Premier Gateway Scoped Subwatershed Study
 Phase 1: Study Area Characterization February, 2016
 Response Matrix

Comments	Response
Conservation Halton – Matt Howatt – May 9, 2016	
Overview	
Conservation Halton staff offer the following comments from a regulatory perspective under Ontario Regulation 162/06 and technical advisory perspective under the Memorandum of Understanding with Region of Halton and local municipalities. The following points are provided as an overview with further detail provided under the appropriate section below.	
Overall, staff appreciate the detailed information provided within the report, specifically regarding Aquatic and Terrestrial Survey Methods, Hydrogeology and Fluvial Geomorphology.	
There is a concern with the flow gauge data being used for validation and calibration of the hydrologic model which must be revisited and agreed upon before established flows can be used in the hydraulic model for hazard delineation.	We note that the flow gauge was sited in consultation with Conservation Halton staff, and the observed trends in terms of runoff response have been verified based upon the characterization of the study area, hence it remains our opinion th

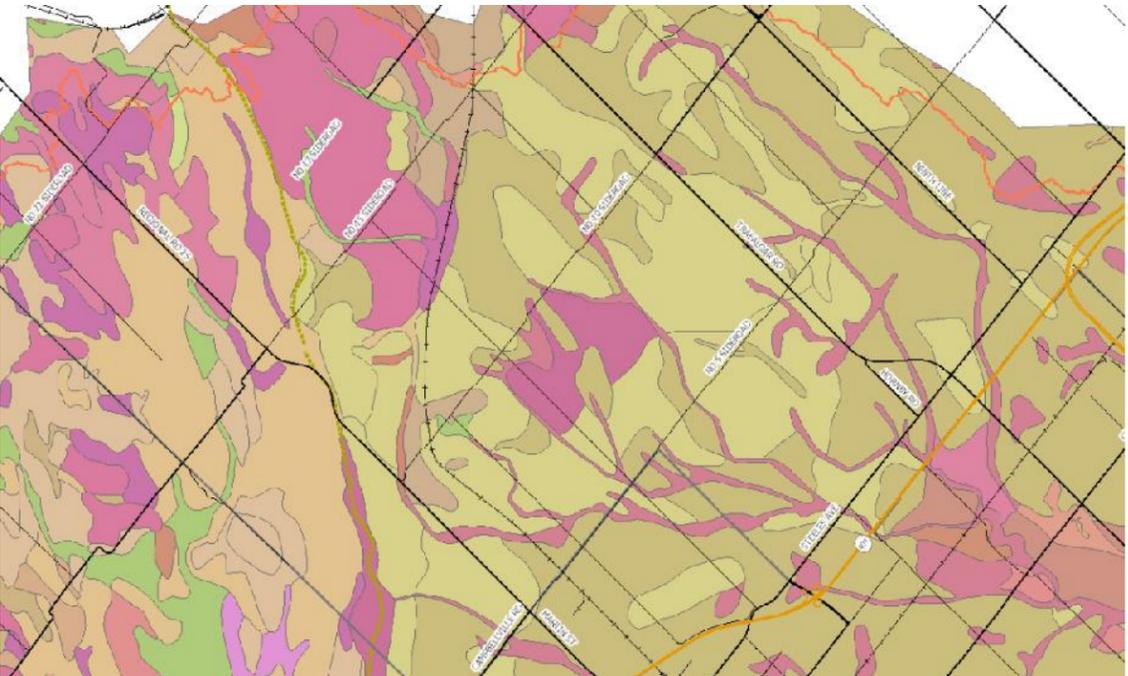
<p>8. Table 2.1.9 Fish Community Assessment Results, Page 35: A photo of the Yellow Bullhead (<i>Ameiurus natalis</i>) is requested to verify the species as it is not typically found within Conservation Halton's watershed.</p>	<p>A photo was not taken of the Yellow Bullhead. Two aquatic biologists conducted the fish community sampling where this species was identified on September 14, 2015. Both biologists have years of experience conducting a variety of aquatic surveys and identifying fish. Both aquatic biologists have</p>

Comments	Response
		excellent fish identification skills and feel confident in their identification of this species.
9.	<p>Section 2.1.5.10 Benthic Invertebrate, Page 36:</p> <p>The lack of Gastropoda and Oligochaetes may not indicate impaired conditions. Site conditions should not be classified based on one or two metrics/indices but on the cumulative results.</p>	It is noted that single metrics do not necessarily characterize the state of a given stream, however the overall condition of each site was based on the analysis of multiple indices. It can also be noted that the lack of any one group may have little effect on the condition of the site. See the response for Comment 5.c) for further discussion.
